# Access Compliance Report

## Public Rights-of-Way

Intersection ID: 47910	Main Street: ROOK_RD	Cross Street: MOUNTAIN_QUAIL_DR	Location: S
ADA ID: C8C99DF1057B	Ramp Type: PerpDiag	Initial Pass/Fail: Fail	Overall Compliance: No
		Severity Score: 10

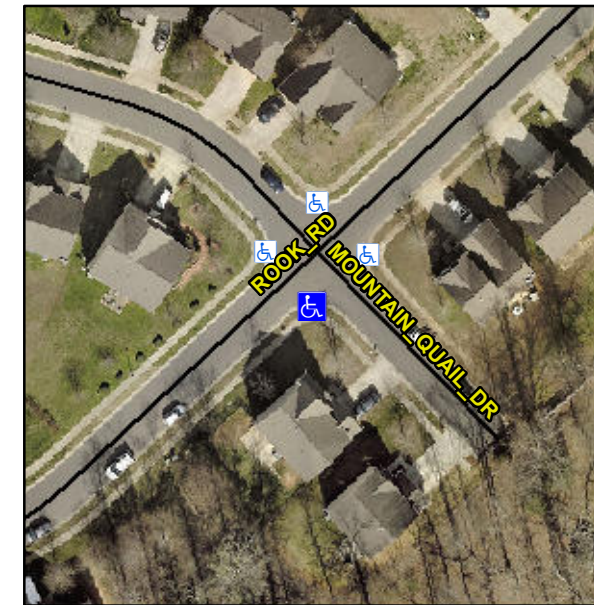
**Not Found, R304.5.1, R304.5.3**

Compliance	Description	Data	Compliance	Description	Data
N/A	Ramp Length (in)	51.0	Yes	Ramp Slope (%)	7.6
No	Ramp Width (in)	37.5	No	Ramp XSlope (%)	3.8
N/A	Flare Type LT	N/A	N/A	Flare Type RT	N/A
N/A	Flare Slope LT (%)	N/A	N/A	Flare Slope RT (%)	N/A
N/A	Flare Traversable LT?	N/A	N/A	Flare Traversable RT?	N/A
N/A	Landing Length (in)	N/A	N/A	DWS Provided?	N/A
N/A	Landing Width (in)	N/A	N/A	DWS Contrast?	N/A
N/A	Landing Slope (%)	N/A	N/A	DWS Length (in)	N/A
N/A	Landing X Slope (%)	N/A	N/A	DWS Full Width?	N/A
N/A	Landing Curb? (Y/N)	N/A	N/A	DWS Offset (in)	N/A
N/A	Shared Landing?	N/A			
N/A	Gutter Ponding?	N/A	N/A	Gutter Slope (%)	N/A
N/A	Gutter Lip Ht (in)	N/A	N/A	Gutter X Slope (%)	N/A
N/A	Painted X Walk1?	No	N/A	Painted X Walk2?	No
	X Walk 1 Direction	To SE		X Walk 2 Direction	To NW
N/A	X Walk 1 Width (in)	N/A	N/A	X Walk 2 Width (in)	N/A
	X Walk 1 Slope (%)	4.8		X Walk 2 Slope (%)	1.4
	X Walk 1 X Slope (%)	2.2		X Walk 2 X Slope (%)	5.3

**Remove & Replace Curb Ramp With Two New Directional Ramps or Equivalent.**
